**S.4.55(1A) Statement of Environmental Effects**

**SECTION 4.55(1A) MODIFICATION APPLICATION – D/2021/1418  
ACACIA APARTMENTS – 330 BOTANY ROAD, ALEXANDRIA CONCEPT DA**

**Figure 3** Comparison between detailed design of the development and the approved building envelope

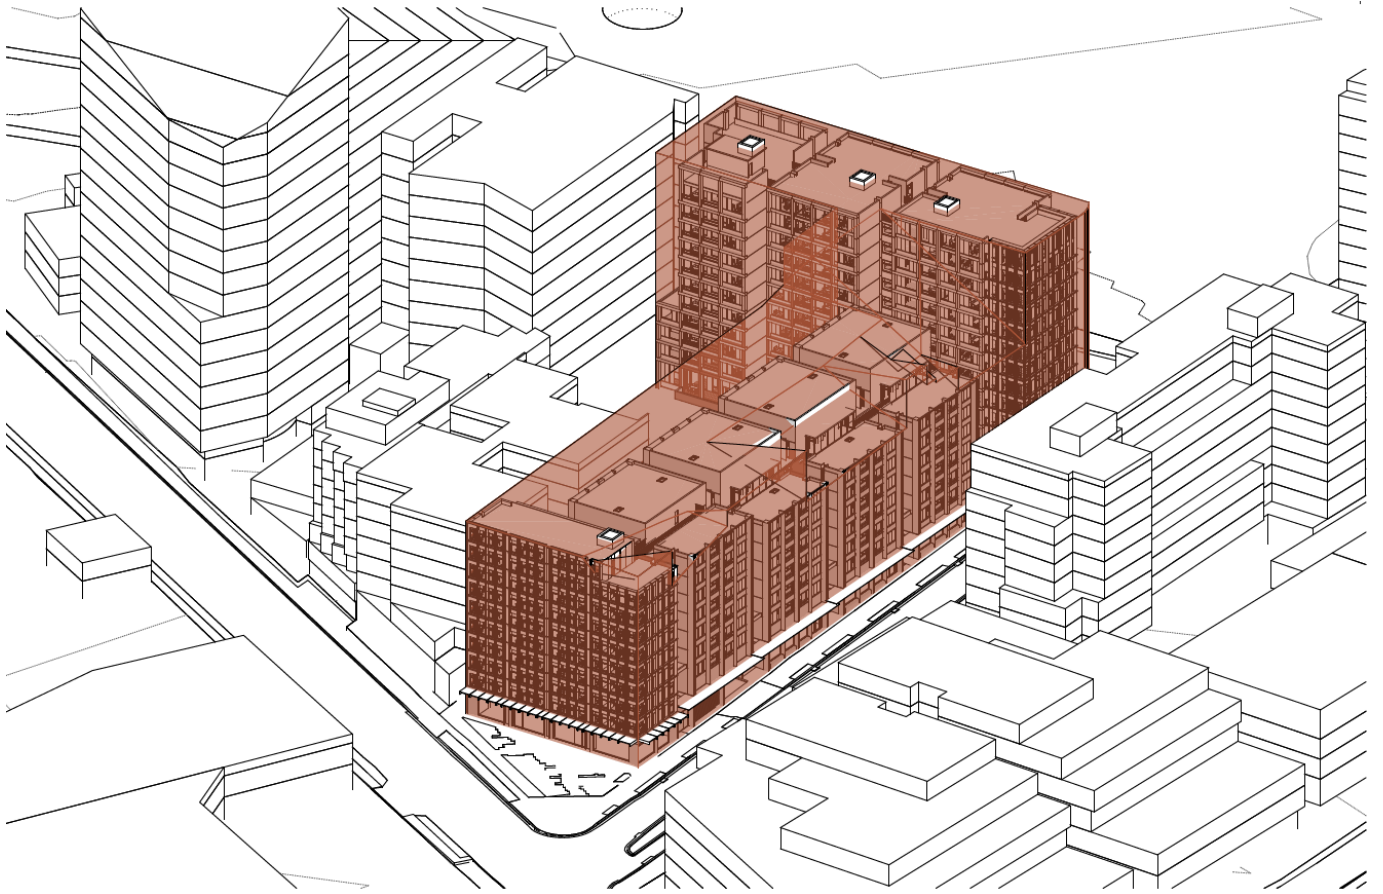
The AJC competition winning scheme protruded beyond the approved building envelope in several locations, to a minor extent. The Detailed DA seeking approval for construction of the development also included some protrusions beyond the envelope, generally consistent with those endorsed with the competition winning scheme.

A 3D image showing the detailed design and the approved building envelope is provided at **Figure 3**. The extent of protrusions can be seen in this image.

**Figure 4** Proposed amended building envelope with detailed design contained within

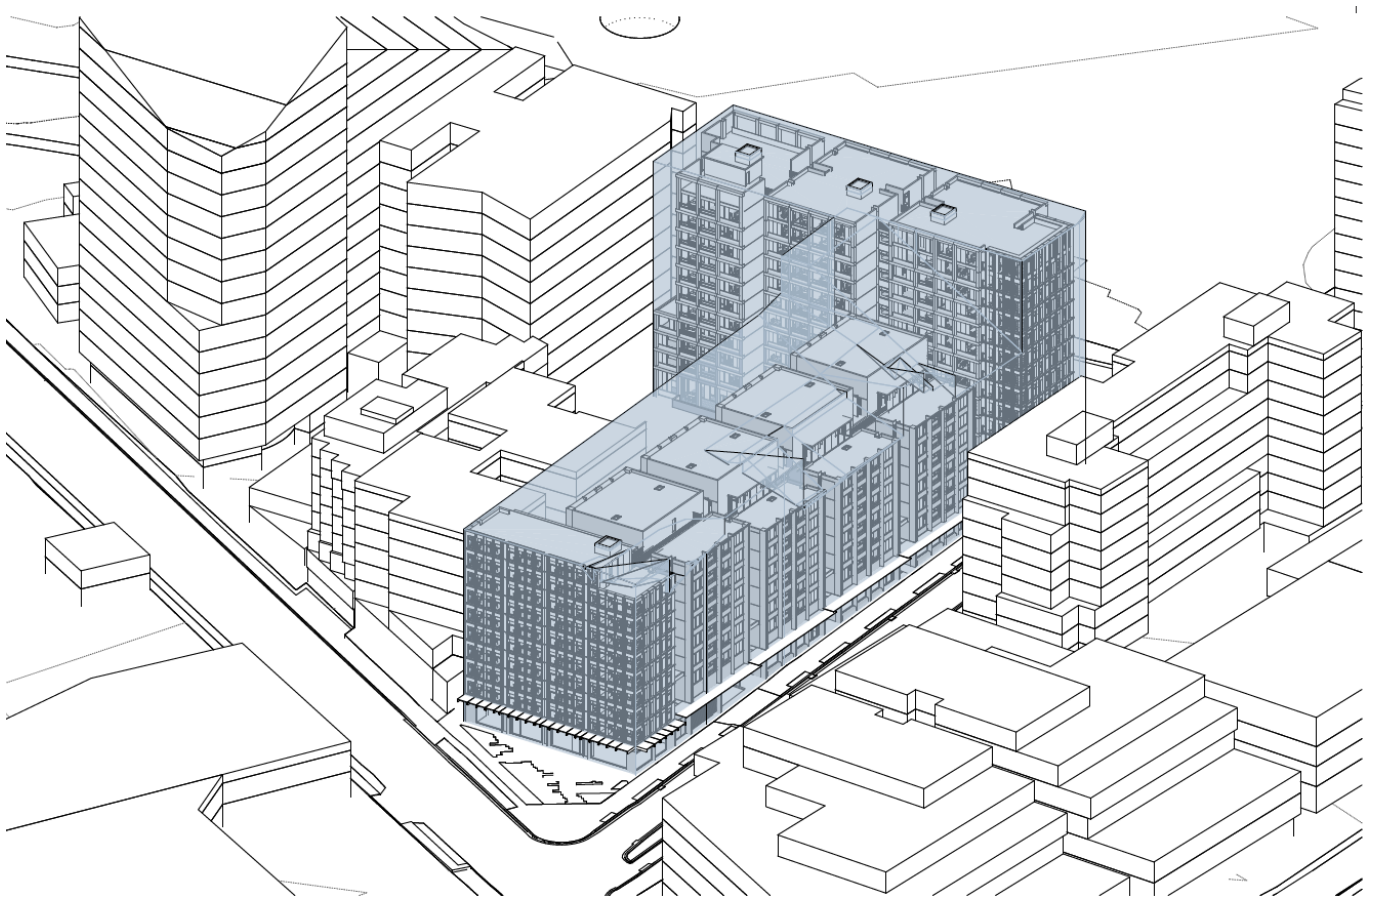
The Detailed DA proposes several minor variations to the concept envelope as approved under D/2021/1484. The amendments are due to design development through the competitive design process and post competition phase. These modifications are required to support the design excellence outcome identified, and in part, were supported by the Selection Panel. The protrusions beyond the approved envelope are shown at **Figure 3**. The proposed amended envelope is shown at **Figure 4**, with the detailed design contained within the amended envelope (with the exception of awnings over the public domain). The proposed amended building envelope site plan is shown at **Figure 5**.

**Figure 5** Proposed amended building envelope site plan, modifications shown in red

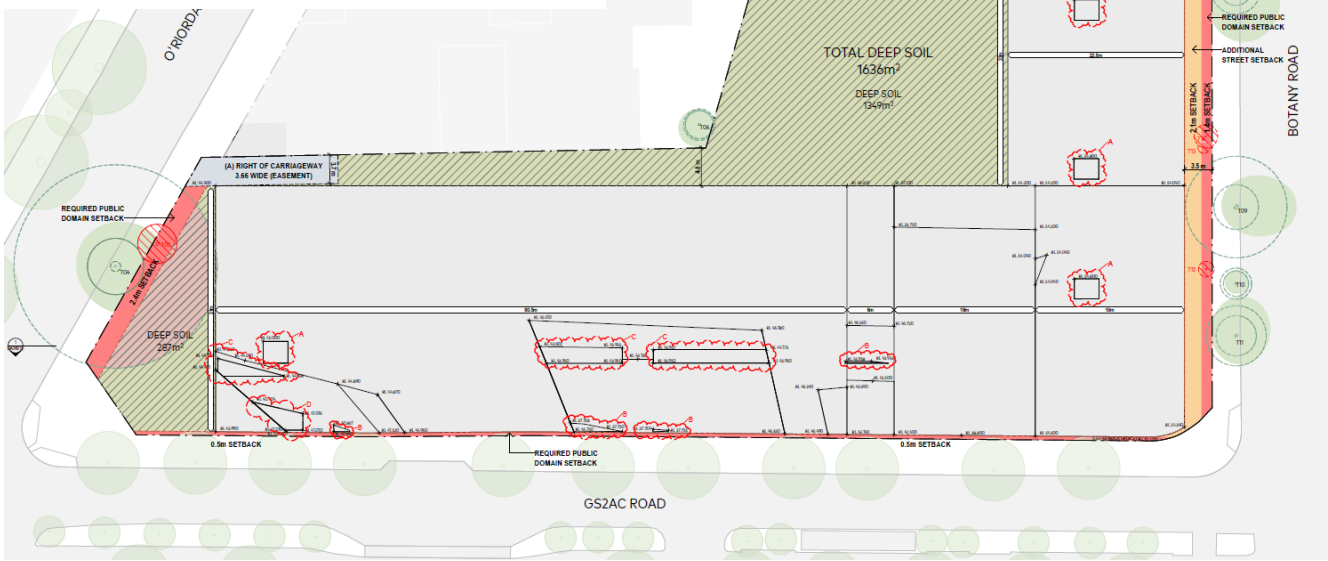
- A Amended to accommodate lift overrun
- B Amended to accommodate parapet
- C Amended to accommodate roof slab & parapet
- D Amended to accommodate minor portion of wall, roof slab & parapet

**Figure 6** Tree identification plan, new trees shown in red box

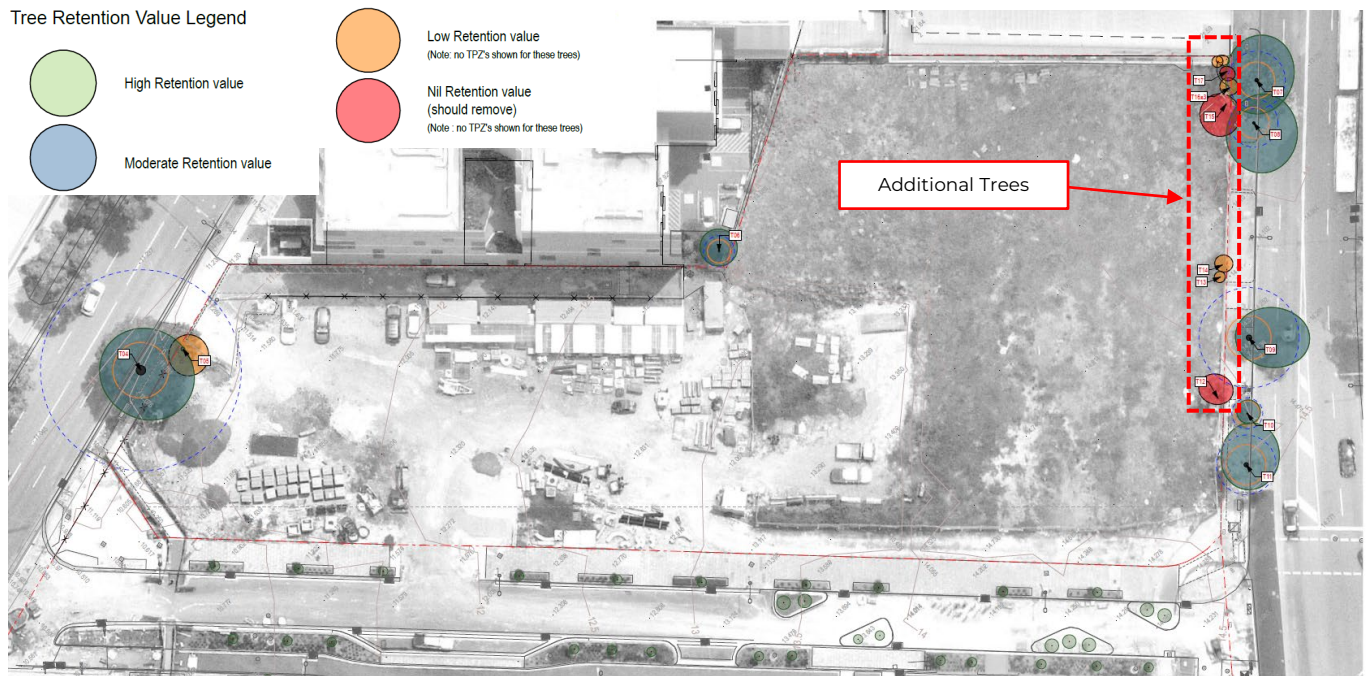
Further arboricultural investigations were undertaken by Arterra to inform the Detailed DA. Several small trees within the site were identified which did not exist at the Concept DA stage (too small to be considered trees). These trees are shown at **Figure 6** and **Attachment B**. All trees are of low to nil retention value. Consent to remove the trees is sought in the Detailed DA, however modifications to the conditions of the Concept DA are required to allow the Detailed DA to seek their removal.

Tree No	Botanical (Common Name)	Location
5	<i>Cupressus macrocarpa</i> (Monterey Cypress Pine)	330 Botany Road
<b>12</b>	<b><i>Robinia pseudoacacia</i></b> <b>(Black Locust)</b>	<b>330 Botany Road</b>
<b>13</b>	<b><i>Corymbia citriodora</i></b> <b>(Lemon Scented Gum)</b>	<b>330 Botany Road</b>
<b>14</b>	<b><i>Eucalyptus botryoides</i></b> <b>(Bangalay)</b>	<b>330 Botany Road</b>
<b>15</b>	<b><i>Robinia pseudoacacia</i></b> <b>(Black Locust)</b>	<b>330 Botany Road</b>
<b>16</b>	<b><i>Eucalyptus microcorys</i> x 3</b> <b>(Tallowood)</b>	<b>330 Botany Road</b>
<b>17</b>	<b><i>Cinnamomum camphora</i></b> <b>(camphor Laurel)</b>	<b>330 Botany Road</b>

**Reason:** As described earlier in this report, trees 12-17 were identified from further arboricultural investigations undertaken to inform the Detailed DA, which did not exist as “trees” at the time of the Concept DA. Condition 21 currently only allows Tree 5 to be sought for removal in the Detailed DA. It is proposed to modify Condition 21 to ensure the Detailed DA can seek removal of the low/nil retention trees 12-17 at the site.

**Figure 8** Hourly sun-eye diagrams of proposed amended building envelope, mid-winter

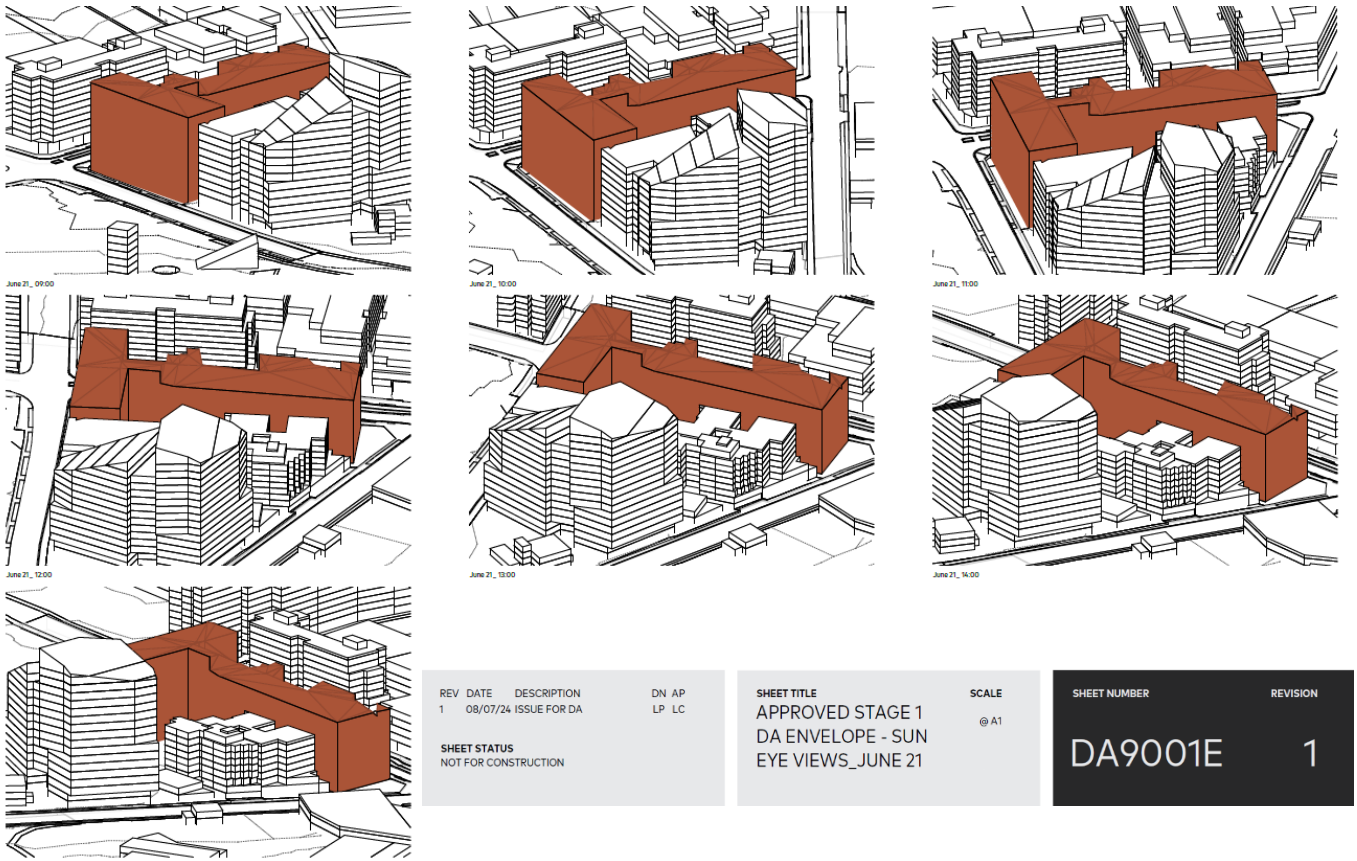
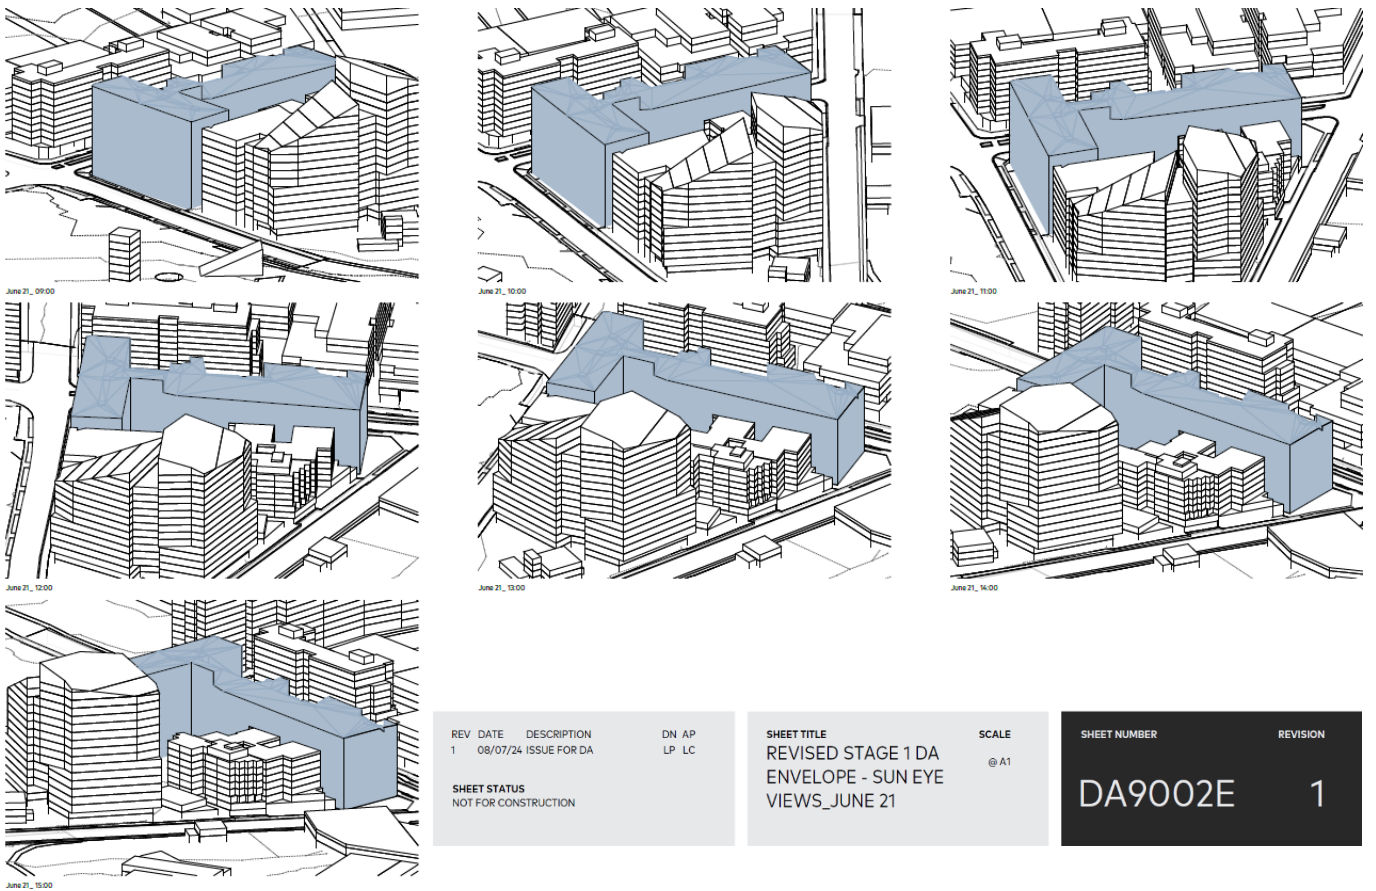
AJC Architects have undertaken an overshadowing study for the modified development (refer to **Attachment A**). This study has examined the overshadowing from the approved and proposed building envelope within the context of existing overshadowing from surrounding buildings within the immediate vicinity of the site. The change in overshadowing is minimal and largely imperceptible from the approved to the amended building envelope.

Mid-winter sun-eye diagrams showing the approved building envelope and proposed amended envelope are provided at **Figure 7** and **Figure 8**, respectively, which show the change is minor.
